AGENDA FOR REGULAR MEETING VILLAGE OF TINLEY PARK PLAN COMMISSION

**Item #1 PUBLIC HEARING: SIP WINE BAR – 17424 OAK PARK AVENUE
SITE PLAN APPROVAL AND VARIATIONS**

**Item #2 WORKSHOP: THE BOULEVARD AT CENTRAL STATION-6701-55 SOUTH STREET
SITE PLAN APPROVAL, GRANTING A SPECIAL USE PERMIT, VARIATIONS AND
PRELIMINARY/FINAL PLAT APPROVAL**

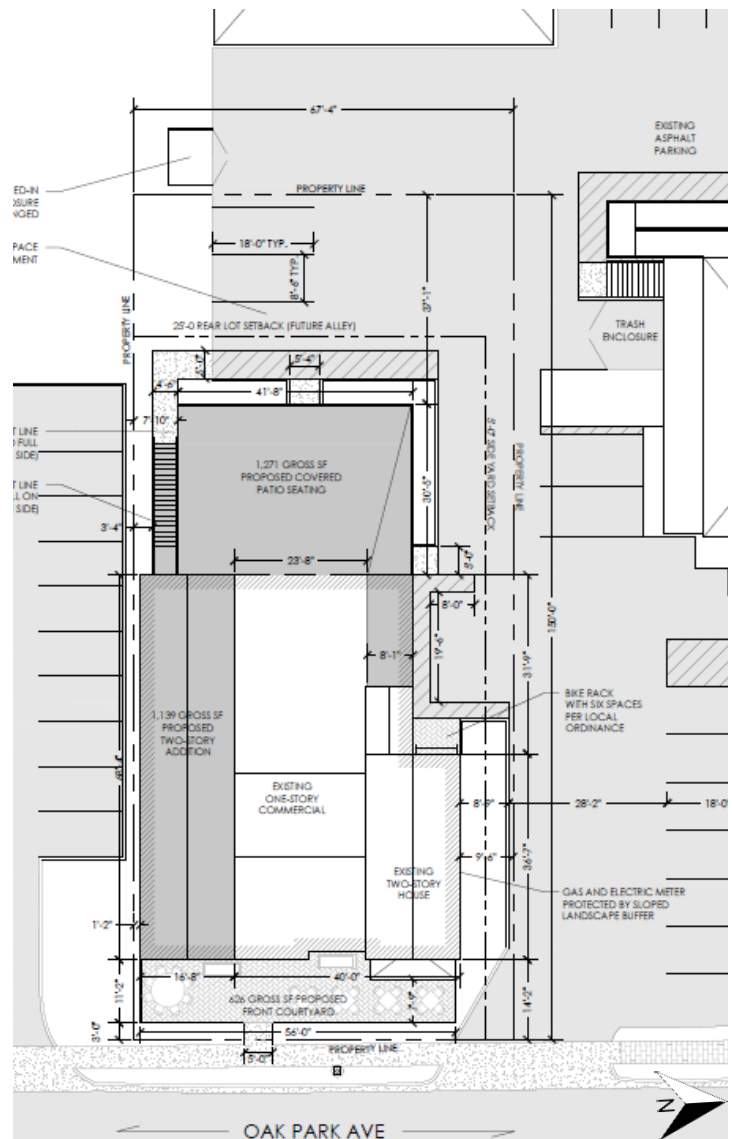
The existing site includes a historically significant residential structure that does not conform to current setback requirements of the Legacy Code. The structure contributes to the local character of the downtown and it is not economically or structurally feasible to relocate the structure. The proposed site plan creates more usable commercial space on the property without completely eliminating parking, landscaping or altering the historical and architectural character of the property.

**Site plan has been updated from the workshop.*

Open Item #2: Submit the plat of easement for a twenty-five (25') wide alley on the west side of the property.

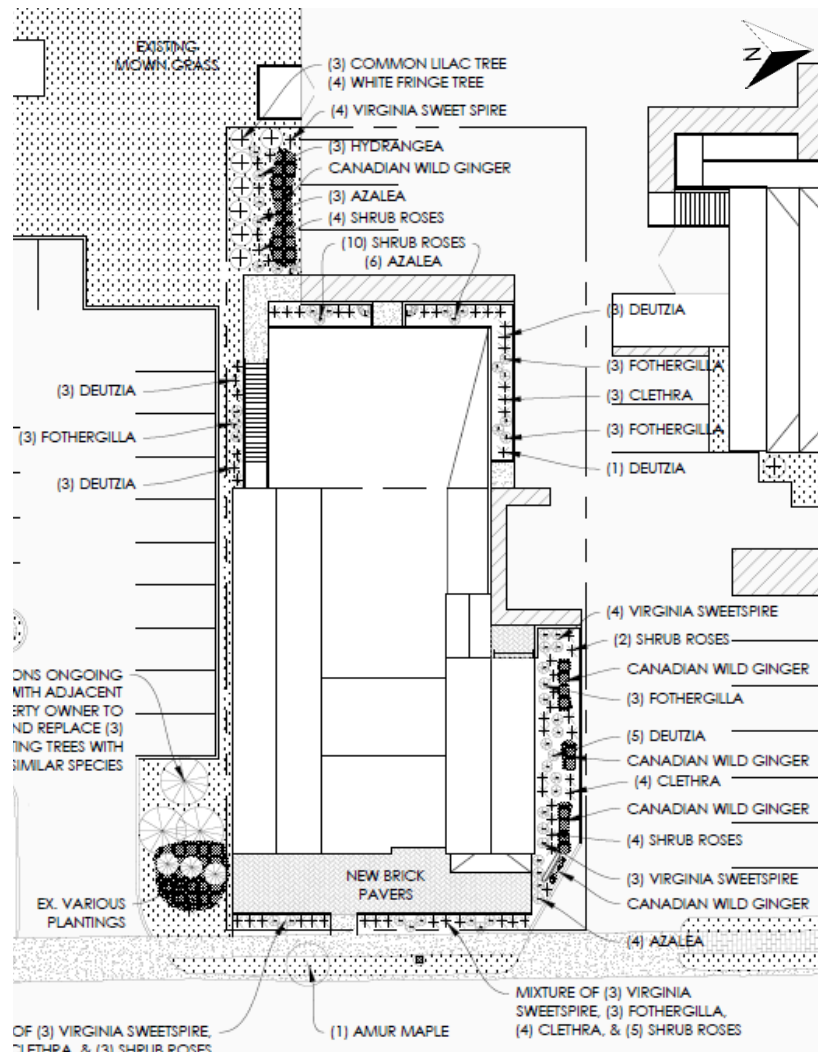
The Legacy Code requires dedication of a twenty-five foot (25') wide alley at the rear of the property. No alley is planned to be completed with this project or in the near future. However, the dedication will allow it to be built and connect to Hickory Street in the future, if necessary. This alley dedication will be completed similar to other redevelopments in the Legacy District. The dedicated alley area will remain striped with on-site parking for the time being. The plat will be prepared by the Applicant's engineer and will be submitted for review and approval at the public hearing.

The Plat of Easement to permit alley access was reviewed and has been attached to the plans. A condition has been placed on the site plan approval requiring that the document is recorded with the Cook County Recorder of Deeds prior to issuance of any permits for this project.

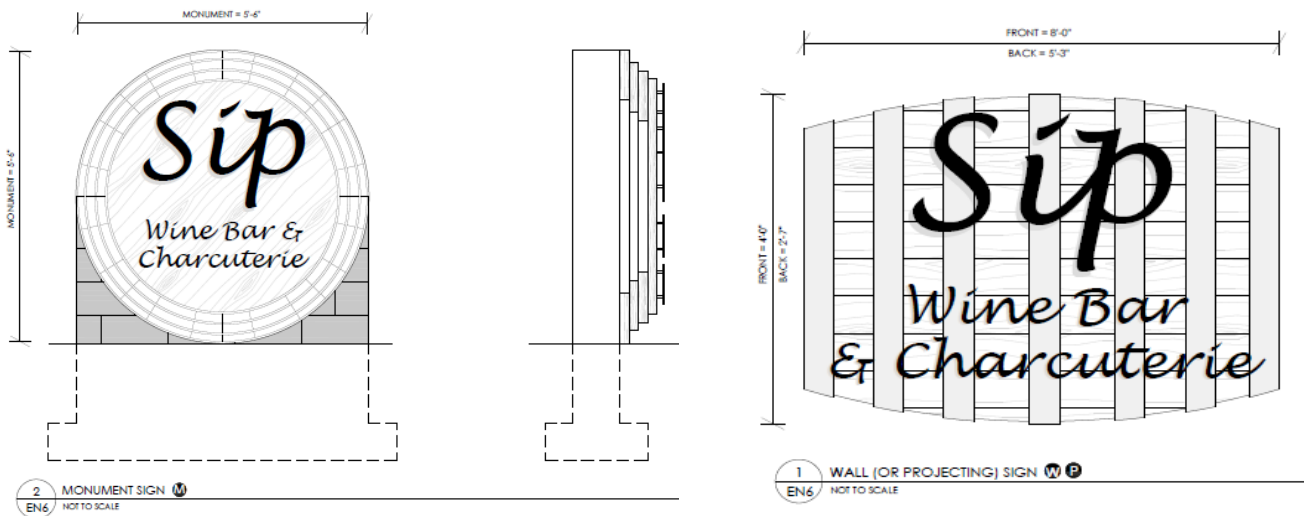
Wall signage is proposed on two (2) elevations; these will be flat mounted or projecting signs. The wall signs will either be non-illuminated or externally illuminated in compliance with the Legacy and Village Codes. A single-faced monument sign is proposed at the north entrance to the site. Due to the existing curb cut dimensions and site layout, the ground sign cannot be placed the full ten feet (10') from the property line and drive aisle. Due to this spacing issue a variance is being requested for the proposed ground sign location. By keeping the sign three feet (3') back from the drive aisle at its proposed location, it is not anticipated that there will be any site line issues or promote incidental contact from vehicles. The sign is relatively small and in compliance with the height and size requirements of the Legacy Code. The sign is proportionate to the site's size and architectural character, yet will still help identify the businesses location. The monument sign will be externally illuminated in compliance with all Village codes. Any light fixture for the ground sign will be screened by landscaping.

Staff's only concern with the proposed signage involves the front façade wall sign that is being placed over a façade architectural detail. Typically covering up architectural details with signage is not permitted by the code and there is a more clearly identifiable sign band area. Staff recommends considering making the wall sign smaller, utilizing a projecting sign, moving the sign to a different location on the facade or flipping the gooseneck lights and wall sign locations as alternatives to the Petitioner's proposed sign location.
